Rivenhall IWMF EP Variation

Gent Fairhead

Schedule 5 Notice – Response

Figure 1: Nitrogen dioxide process contribution

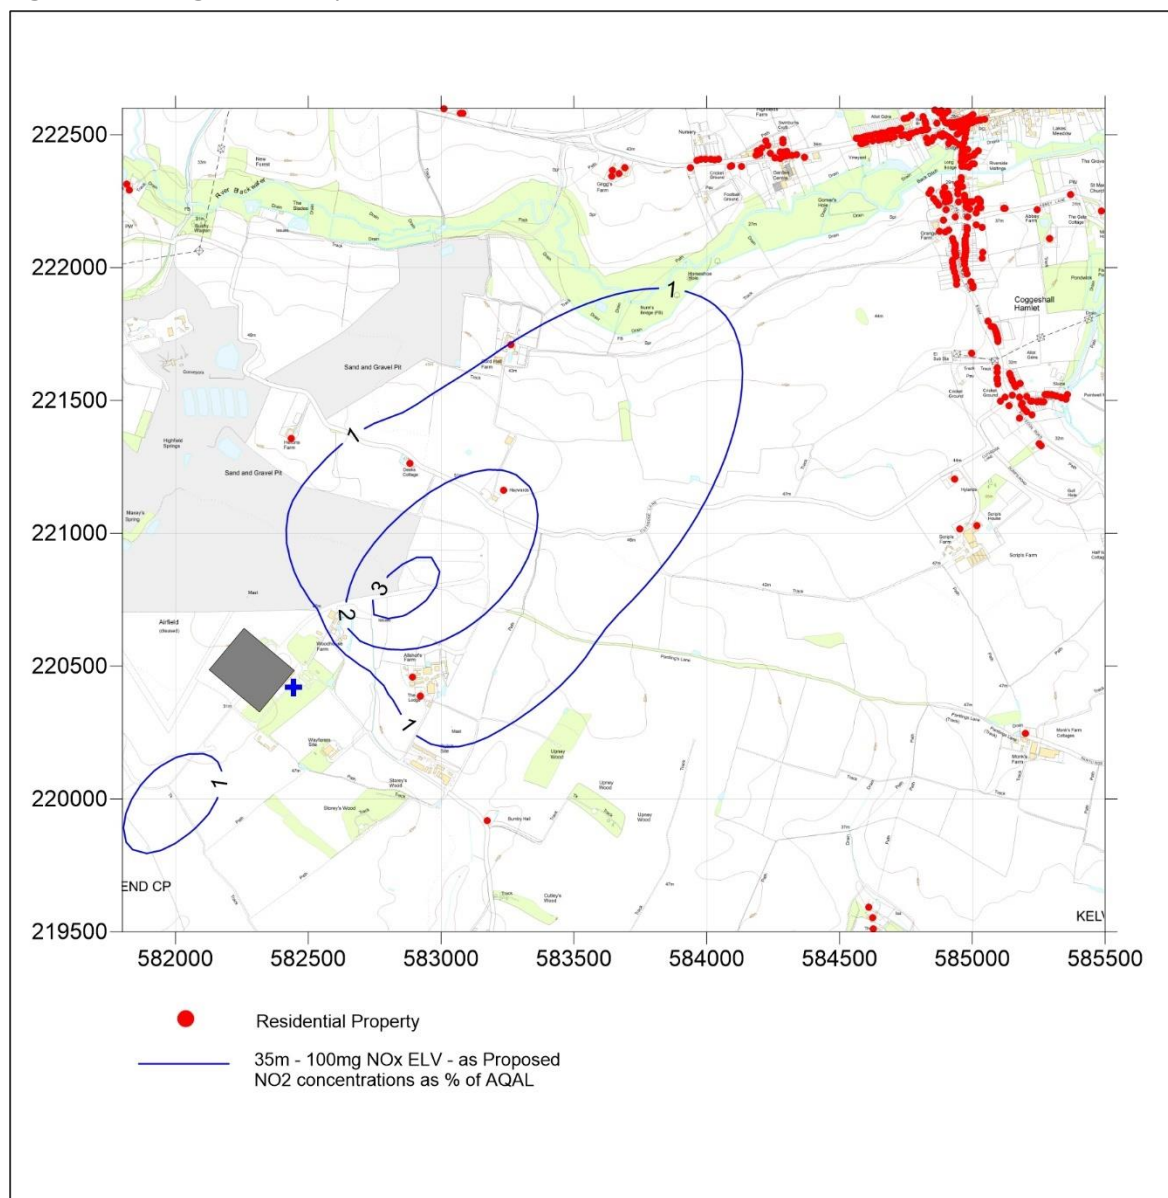
At present your application suggests there would be an increase in process contributions (as shown below), but does not demonstrate why this increase is equivalent or better than the existing proposal.

- Table 3.2 predicts an increase in NO_x annual process contribution from 2.19% to 3.27% of the Environmental Standard (ES).
- Table 3.3 predicts an increase in NO_x annual process contribution at one receptor (All Shots Farm) from 0.60% to 1.40% of the ES so that it cannot be screened out as insignificant
- Table 3.2 VOCs process contribution (as benzene) increases from 2.97% to 6.56% of the ES
- Table 3.2 VOCs process contribution (as 1, 3-butadiene) increases from 6.60% to 15.57% of the ES

The EA has focussed on two concerns.

First, the EA notes that the predicted process contribution at the point of maximum impact has increased. While this is correct, it does not mean that this will have any environmental effects. The point of maximum impact with the 35m stack is closer to the IWMF (the Facility), as would be expected. This location is uninhabited, as shown in Figure 1 below, and so there is no risk to human health from the change in process contribution at the point of maximum impact.

Figure 2: Change in annual average nitrogen dioxide concentration.

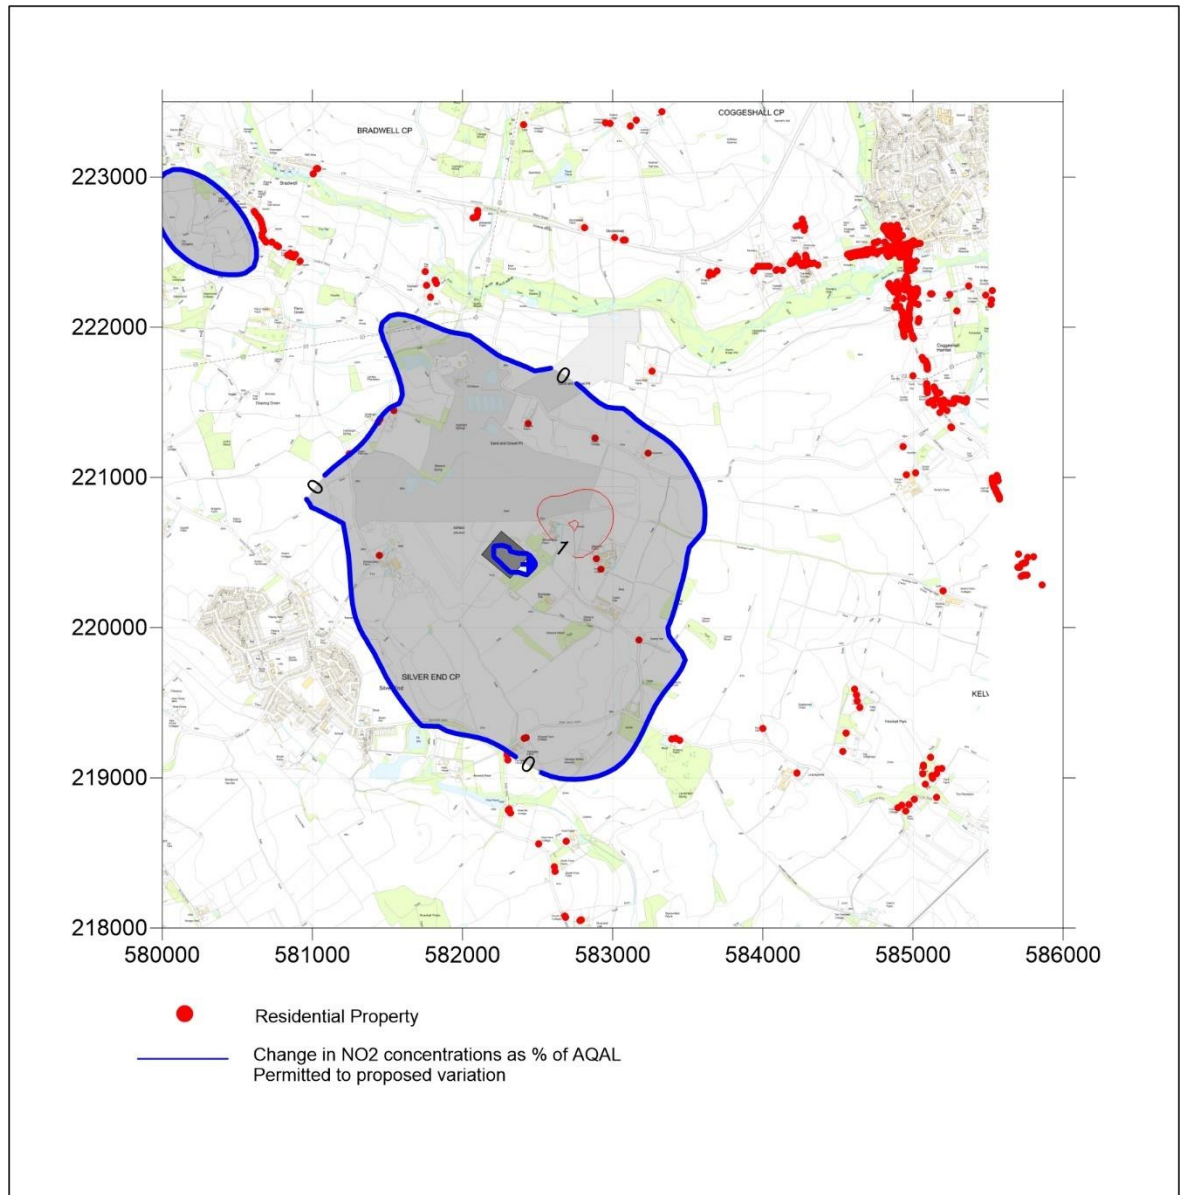
Secondly, the EA notes that the predicted process contribution at one receptor (Allshots Farm/The Lodge) has increased so that it can no longer be screened out as insignificant. This is correct. However, it should be balanced against the reduction in process contribution at a number of other receptors. The maximum process contribution at Curd Hall Farm has reduced, so that it can nearly be screened out as insignificant, and the concentration in Coggleshall and Silver End has reduced; therefore, reducing the overall impact at the more populated areas which will be affected by emissions from the IWMF.

This is illustrated in Figure 2 below, which shows the change in maximum annual average nitrogen process contribution of dioxide as a percentage of the AQAL. The maximum process contribution increases in the shaded area, which includes a small number of isolated receptors, and decreases outside this area, which includes Coggleshall and Silver End. The area in which the process contribution increases by more than 1% of the AQAL is very small and contains no receptors.

Figure 3.17: Continuously monitored TVOC emissions to air from reference lines incinerating predominantly MSW

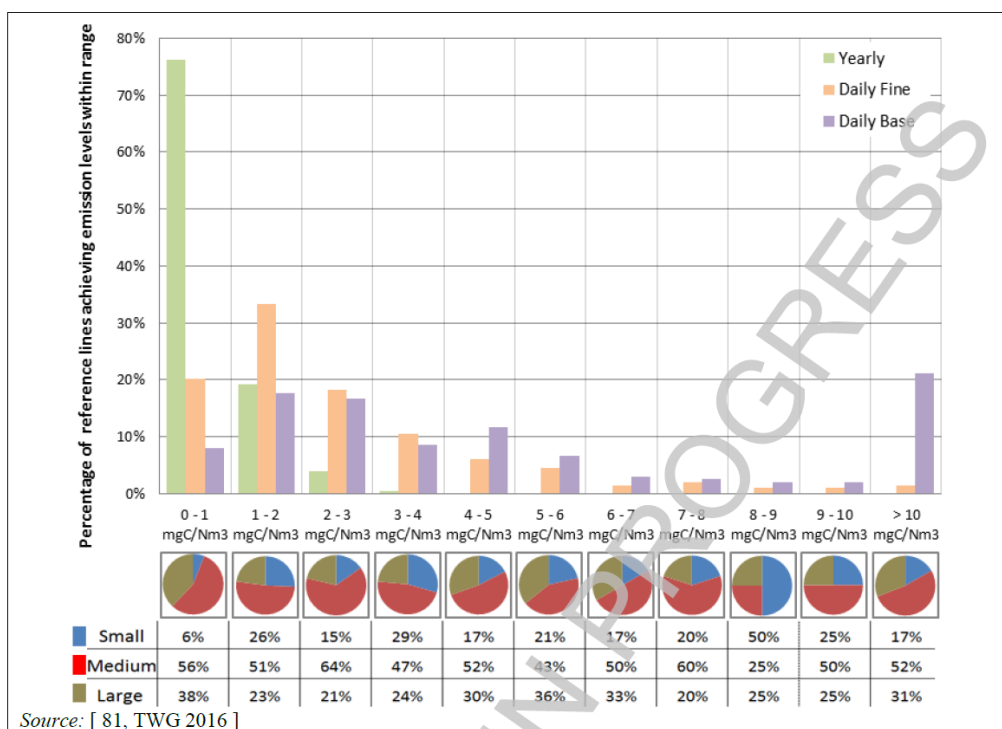
In line with the requirements for demonstrating alternative BAT techniques, provide further information to demonstrate why your proposals for a 35 m metre stack with advanced SNCR abatement will provide a level of environmental protection that’s better than or equivalent to the 58 m stack and SNCR design which has previously been determined as BAT.

- a. Oxides of Nitrogen
- b. Volatile Organic Compounds
- c. Heavy metals

1. First, the assessment is based on the assumption that the Facility will operate at the emission limit of 10 mg/Nm³ for VOCs for the entire time and that the emissions of VOCs will consist of entirely benzene or entirely 1,3-butadiene. Both of these assumptions are considered to be very conservative.
 - a. Figure 3.17 in the final draft WI BREF, reproduced below, shows that the annual average VOC emissions were less than 1 mg/Nm³ for 76% of municipal waste to energy plants in the sample in 2015, less than 2 mg/Nm³ for 95% of them and less than 3 mg/Nm³ for virtually all of them. This indicates that the actual emissions of VOCs are likely to be less than 20% of the emission limit.

Figure 3.33: Periodically monitored Cd+Tl emissions to air from reference lines incinerating predominantly MSW

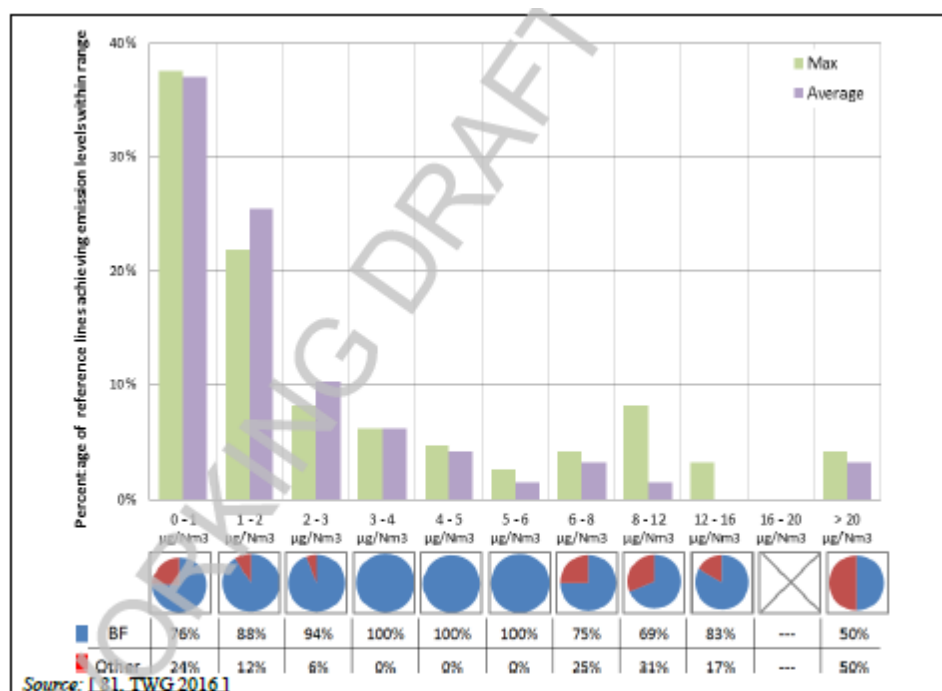
Demonstrate and provide evidence to support why the Applicant is confident this emission limit is now achievable and explain why emissions are now proposed to be lower than in the previous application.

The emissions of cadmium and thallium from European EfW plants are shown in the final draft WI BREF. Figure 3.33 from page 180 of the final draft WI BREF is reproduced below and summarises emissions data from 197 municipal waste-to-energy lines. Only six of the reference lines had emissions which exceeded the BAT-AEL. This was the evidence used to set the BAT-AEL and clearly shows that it can be consistently achieved.

Figure 8.15: Daily and yearly average emission levels for continuously monitored NO_x emissions to air from reference lines incinerating predominantly MSW (1/3)

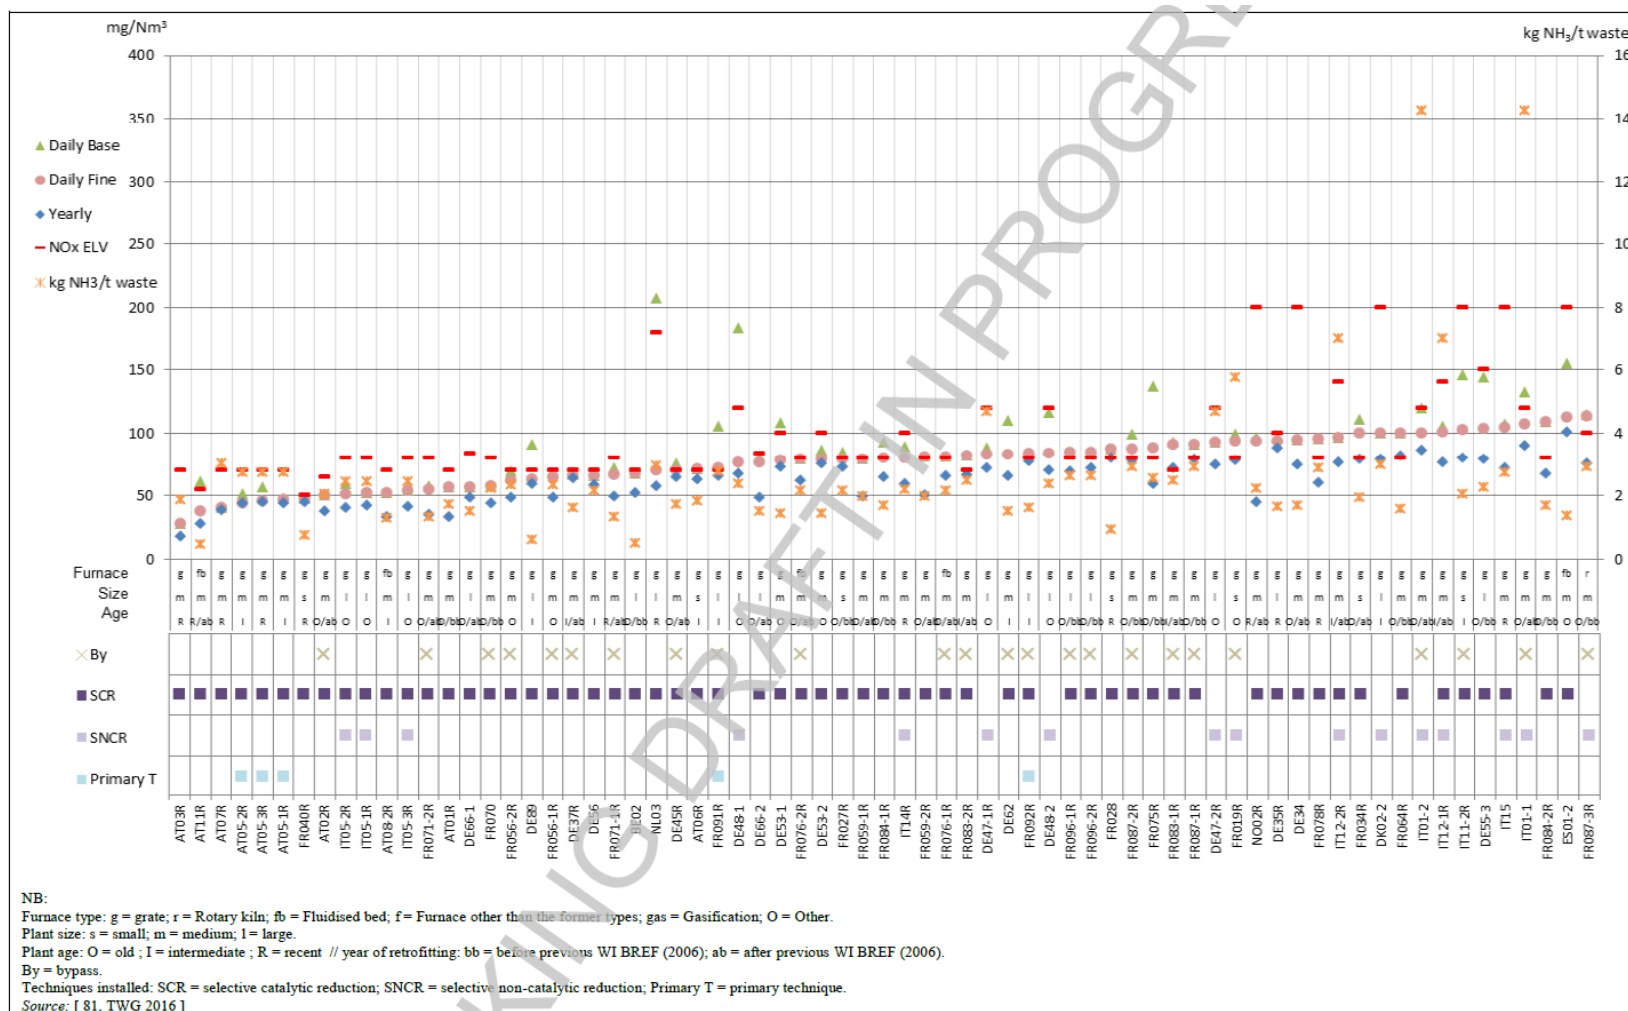
Provide further quantifiable evidence and representative operational data from an equivalent representative plant or plants to demonstrate why your proposal can be considered to represent Best Available Techniques (BAT).

1. As part of the data gathering exercise to support the new waste incineration BREF, emissions data was collected from a variety of energy-from-waste plants across Europe. The data is for plants operating in 2015. This data is published in Annex 8.6 of the draft final WI BREF. Figure 8.15, reproduced in Appendix A, shows the plants with the lowest NO_x emissions (Figures 8.16 and 8.17 show the plants with higher emissions). The figure shows, for each plant, the annual average (blue diamond), the highest daily average excluding other than normal operating conditions ("daily fine", pink circles) and the highest daily average except for maintenance and when the plant is burning support fuel ("daily base", green triangle). These are explained on page 149 of the draft final WI BREF. Of these, the most relevant is the "daily fine" as this shows the emissions data which are achieved on a consistent basis.

The figure shows that there are at least 9 lines across Europe which achieved annual average emissions of NO_x below 100 mg/Nm³ with SNCR only (DE48-1, DE47-1R, DE48-2, DE47-2R, FR019R, DK02-2, IT1-2, IT1-1, FR087-3R) and that for seven of these lines, this emission level was achieved on a daily basis, excluding other than normal operating conditions (the "daily fine" concentration). The seven lines range from 7.5 tph to 320,000 tpa and are considered to be representative of the proposed capacity for the CHP Plant.
